# Sneak Circuit Analysis of F-4C Flight Control System

DOCUMENT NO. D2-118545-1

MODEL NO. F-4C CONTRACT NO. F33657-74-C-0686

FIGURE 1: PITCH CANCELLOR AMPLIFIER

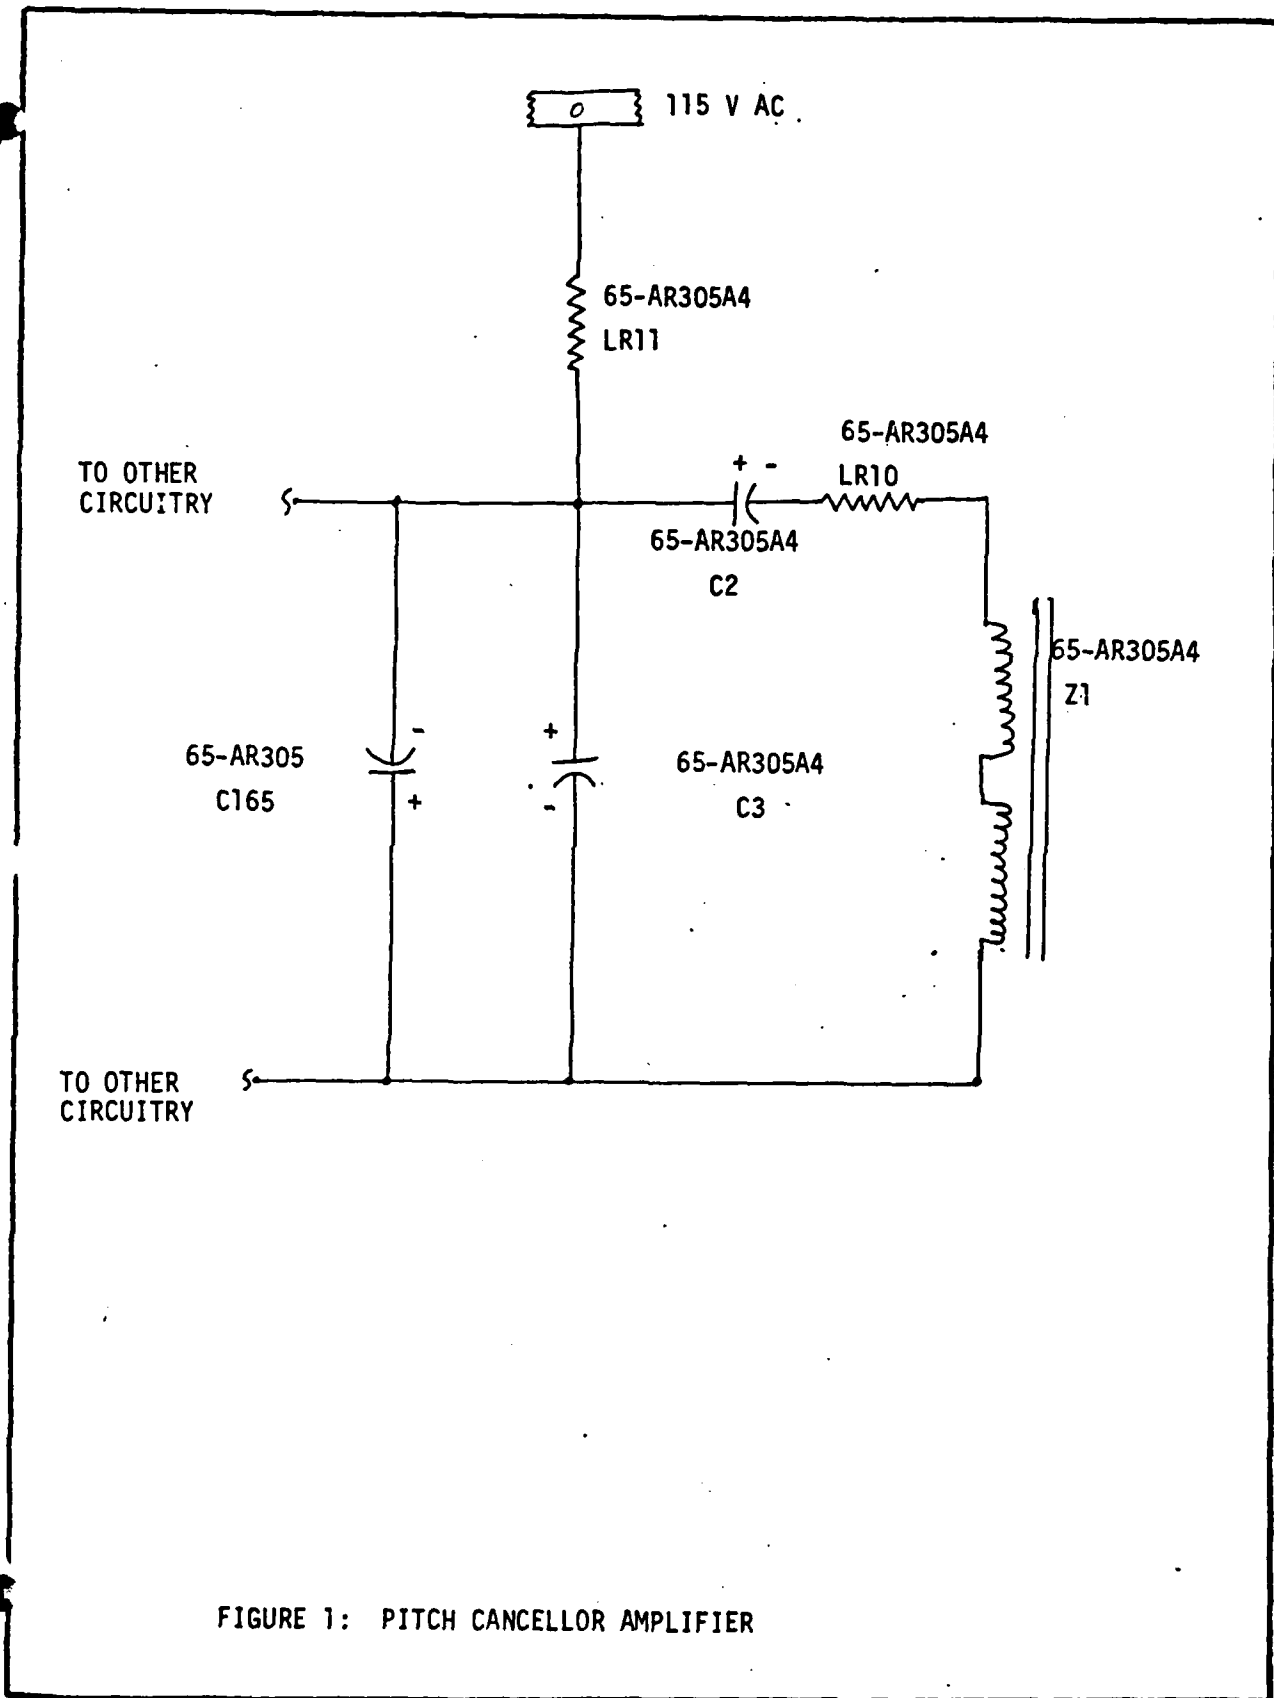
Capacitor C165 in ref. des. 65-AR305 is wired in parallel with capacitor C3 in ref. des. 65-AR305A4. The drawings in references 2 and 3 above show these capacitors wired with opposite polarity as shown in Figure 1. If these are electrolytic capacitors, one of them may burn out.

The drawings for the YAW Cancellor Amplifier does not show the Capacitors in these locations with opposite polarities.

Reverse polarity of capacitor C165.

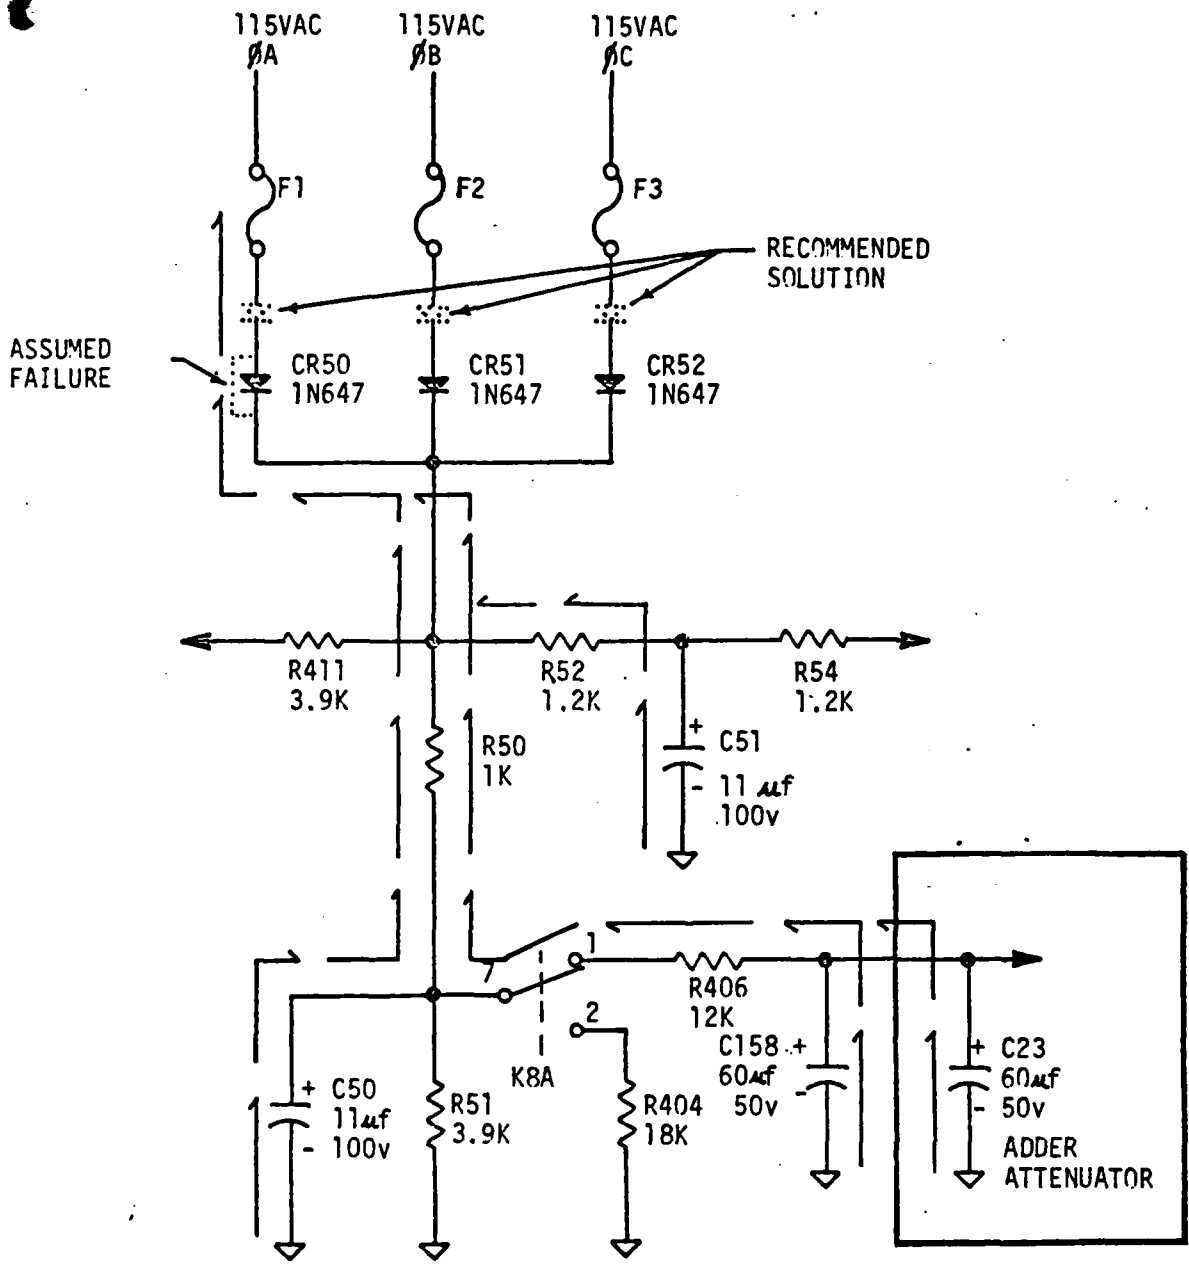
Diodes CR50, CR51 and CR52 rectify the incoming 115VAC, 400 Hz, 3 phase power to provide 135 VDC to the Adder Attenuator and Electronic Switch Monitor. This voltage is filtered by capacitors C50, C51, C158 and C23. C23 is located in the Adder Attenuator Module. The remaining capacitors are chassis mounted components. Should any of the diodes fail in the shorted mode (then fail open) each of the four capacitors will be subjected to reverse current during the negative portion of the cycle for the phase containing the shorted diode. Per reference 4 these capacitors are of the Tantalum Sintered-Slug type. Per MIL-STD-198C, Section 802, paragraph 2.1.2 these capacitors cannot withstand any reverse voltage.

Add one additional diode in series with CR50, CR51 and CR52 as shown in the attached figure.

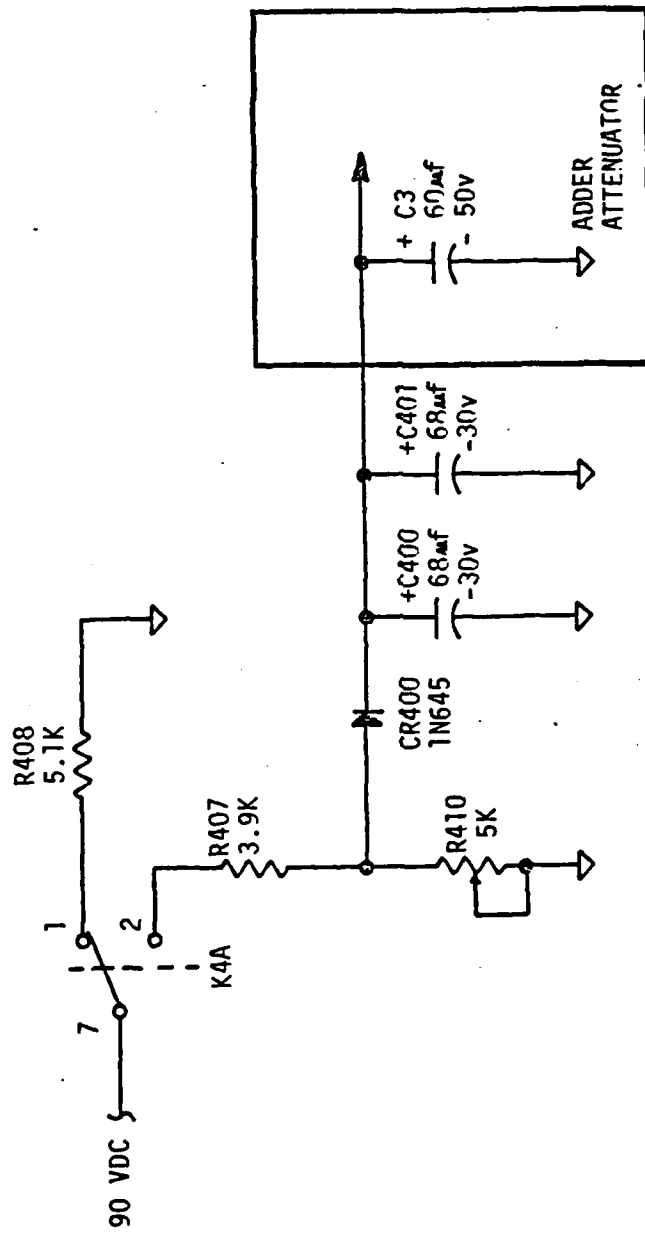
Capacitors C400, C401 in the chassis wiring and capacitor C3 in the Adder Attenuator are connected in parallel as shown in the attached figure. The working voltage for C400 and C401 is 30 volts and for C3 is 50 volts. Per reference 2, the nominal voltage across these capacitors is 31.9 volts. Depending upon the setting of R410 this can be as high as 39.8 volts. In either case, the working voltage for C400 and C401 is exceeded. This is in violation of MIL-STD-198C, Section 802, Paragraph 2.7.2.

Replace C400 and C401 with capacitors with sufficient working voltage to withstand the applied voltages.

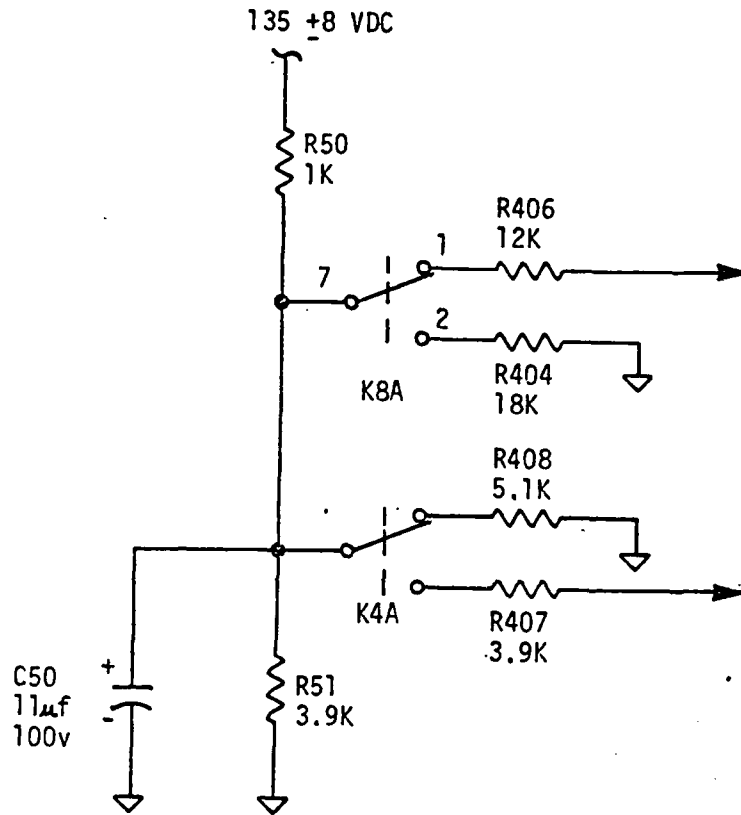
Capacitor C50 filters the 90 VDC used to control the Pitch and Roll faders in the Adder Attenuator module. During the switching time of relay K4A the voltage applied to C50 is 109 VDC due to the loss of the 5.1K $\Omega$  load impedance. This exceeds the rated working voltage of the capacitor in violation of MIL-STD-198C, paragraph 6.5(d).

Replace capacitor C50 with a capacitor with sufficient working voltage to withstand the applied voltage.

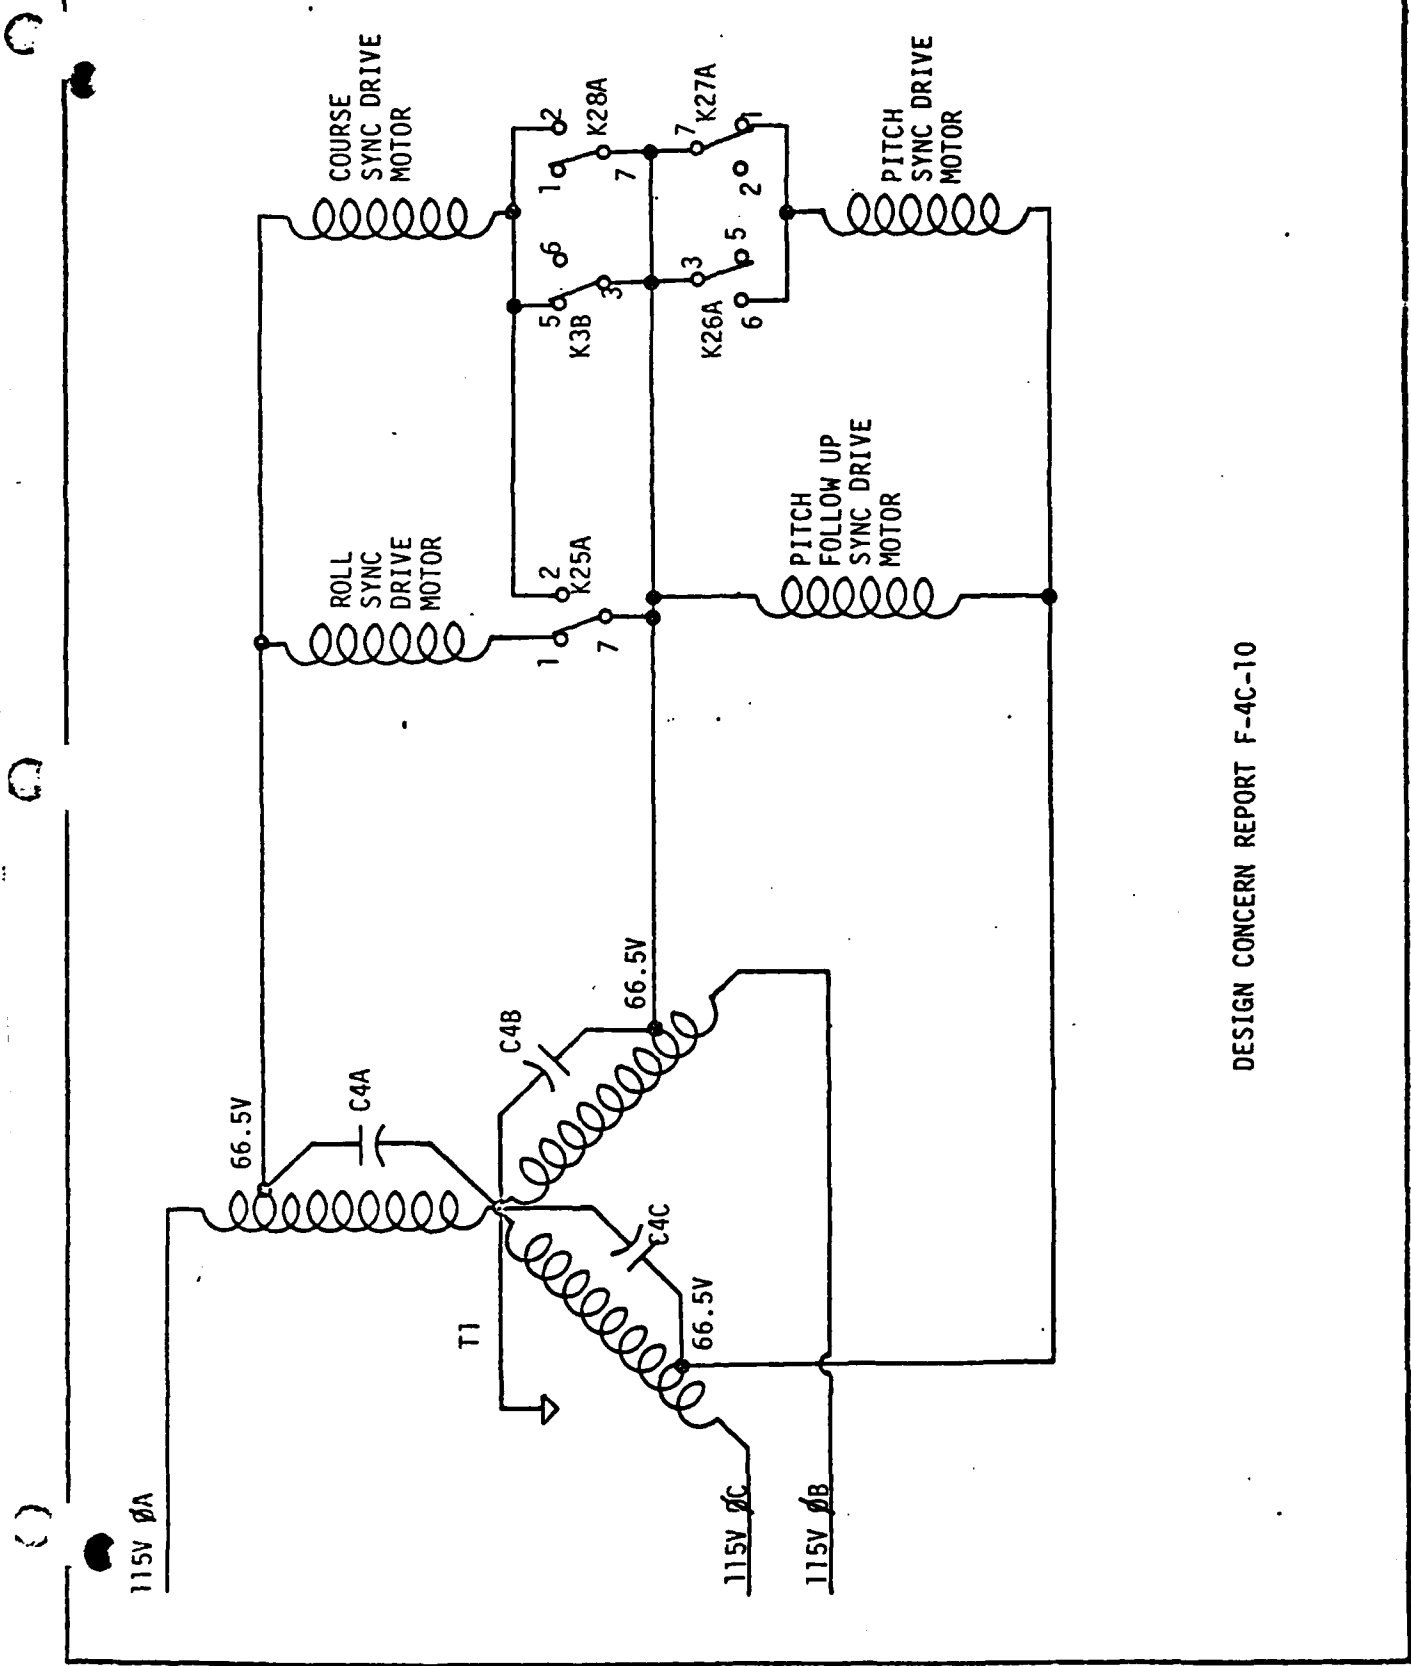
Capacitors C4A, C4B and C4C, P/N CK06BX103M, are Fixed, Ceramic dielectric devices rated at .01  $\mu$ f, 200 VDCW. These capacitors are used to both tune the circuit and suppress transients caused by opening the circuits to the fixed phase winding of the Pitch, Roll and Course Sync Drive Motors as shown in the attached figure. Per reference 3, paragraph 4.7.5.1 these capacitors must withstand 500 VDC without a dielectric failure. Considering the high failure rate of these capacitors, it is probable that the induced voltage transients exceed the dielectric breakdown voltage thus causing capacitor failure.

Replace capacitors with devices that will withstand the induced voltage transients without dielectric breakdown.

FIGURE 1 G-LIMIT ACCELEROMETER AND RELAYS

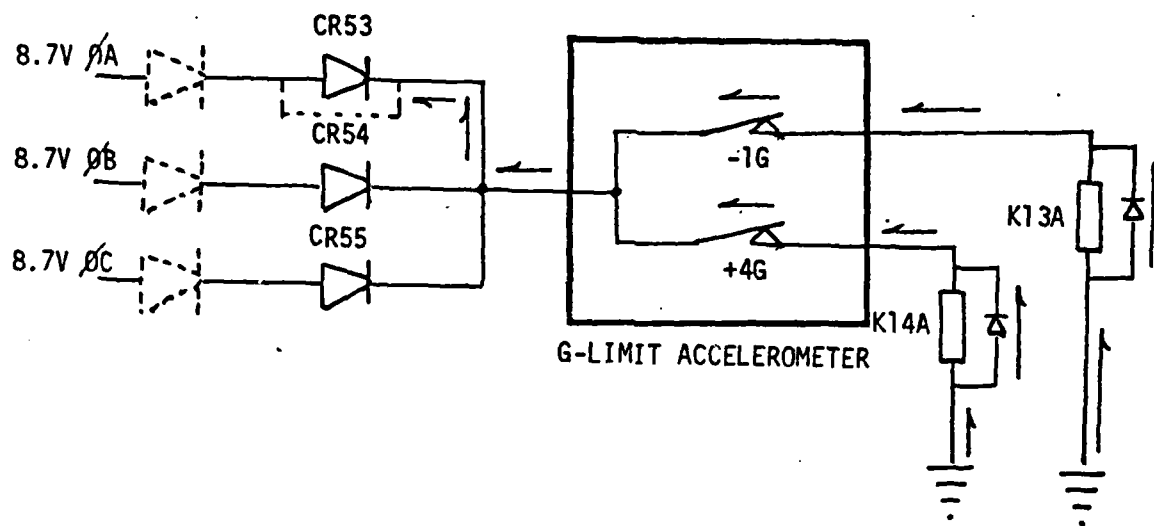
Diodes CR53, CR54, and CR55 rectify the incoming 8.7 VAC 400 Hz, 3-Phase voltage to provide 9.5 VDC to the G-limit relays through the G-limit accelerometer switches as shown in the attached Figure 1. If any of the three diodes fail in the shorted mode, the voltage to the G-limit accelerometer will be driven negative during the negative cycle of the phase containing the shorted diode. This will cause current flow through the suppression diodes of K13A and K14A in the forward direction, as shown, causing them to fail open. Also, during the negative portion of the shorted phase, the two remaining diodes will supply excessive current, causing one or both to fail open. The negative voltage at the input to the G-limit accelerometer will have the same effect as opening the G-limit switches: De-energizing of K13A and K14A and disengaging AFCS (AFCS engage logic is shown in Attached Figure 2).

Add an additional diode in series with each of the three diodes as shown in Figure 1.

T.O. IF-4C-2-16, Change 6, March 1, 1974  
 Figure 2-39, Change 5

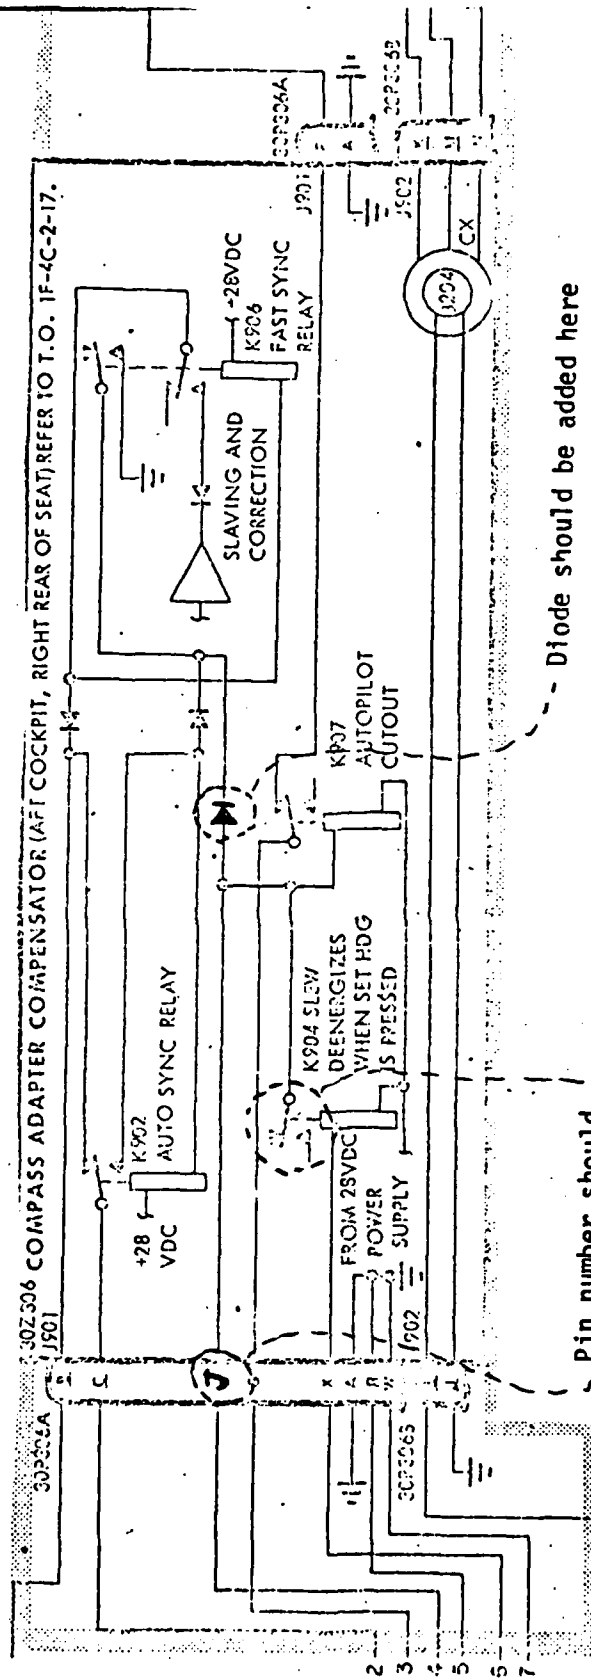
T.O. IF-4C-2-16, Figure 2-39, Change 5, disagrees with T.O. IF-4C-2-17, Change 7, April 15, 1974, Figure 2-24, Original, in the following particulars:

- 1) Pin number J was not labeled in Figure 2-39.
- 2) Diode shown on the attached sheet is present in Figure 2-24, but missing from 2-39.

Diode should be added here

Pin number should be added here

Diode shown in T.O. IF-4C-2-17, Figure 2-24, should be added to T.O. IF-4C-2-16, Figure 2-39.

"Pin J" on connector 30P306A should be added to Figure 2-39.

1) T.O. 5A1-2-42-2, Figure 5-12, Change 2

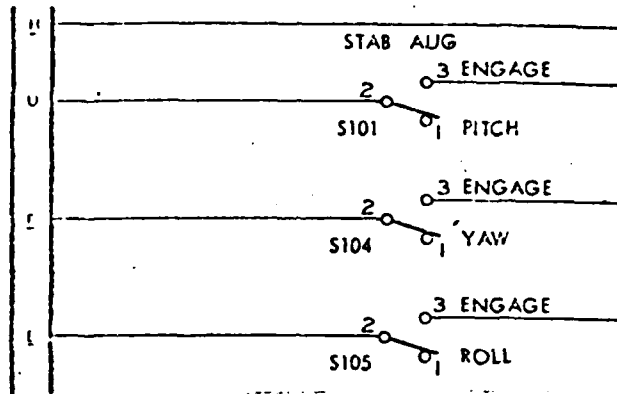
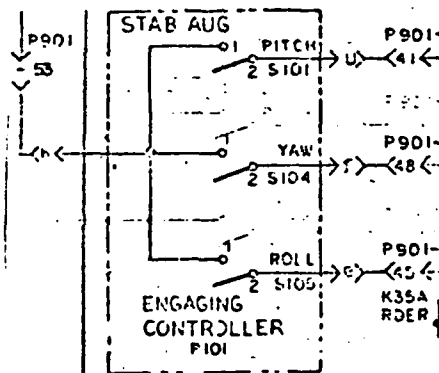
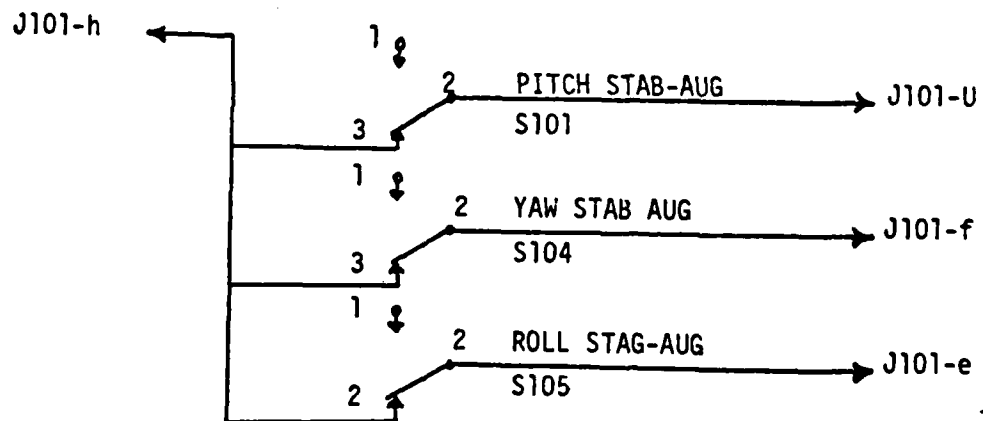
- 1) T.O. 5A1-2-42-2, Figure 5-12, Change 2  
Normally Open, Latching. H common to all pin 3 contacts.

- 2) Schematic, Electrical-System AN/ASA-32M Control Circuits  
Drawing #281E402, Sheet 4, Revision A, 2-16-71  
Normally Open, Latching. H common to all pin 1 contacts.

- 3) Schematic, Electrical-Engaging Controller  
Drawing #702187, Rev. C, 5-7-69  
Normally Closed, Momentary. H common to all pin 3 contacts.

Insufficient information to determine correct configuration.
